PARTS DEPARTMENT BULLETIN

BULLETIN NUMBER: 2011-1

SUBJECT: AC VOLTAGE SENSE RESISTOR BOARD CHANGE

MODELS: ALL D-NET GENERATOR MODELS

VOLTAGE SENSE
RESISTOR BOARD
PN#053762 (NEW)

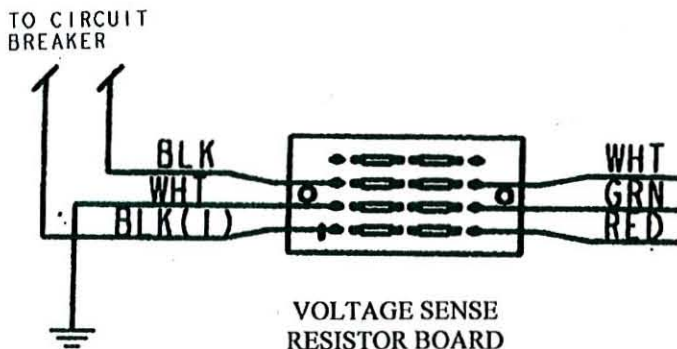
The Voltage Sensing Resistor Board pn#052719 (illustrated below) has been redesigned to add an additional voltage sensing circuit.

The new Voltage Sensing Resistor Board will have pn#053762 and will replace the existing board pn#052719 in production units and for parts orders received from the field.

Note: Connections NA, NB and NC are Neutral sensing connections. These connections will be illustrated on the various AC Configuration stickers furnished with each unit and also in the appropriate Operator's Manual.
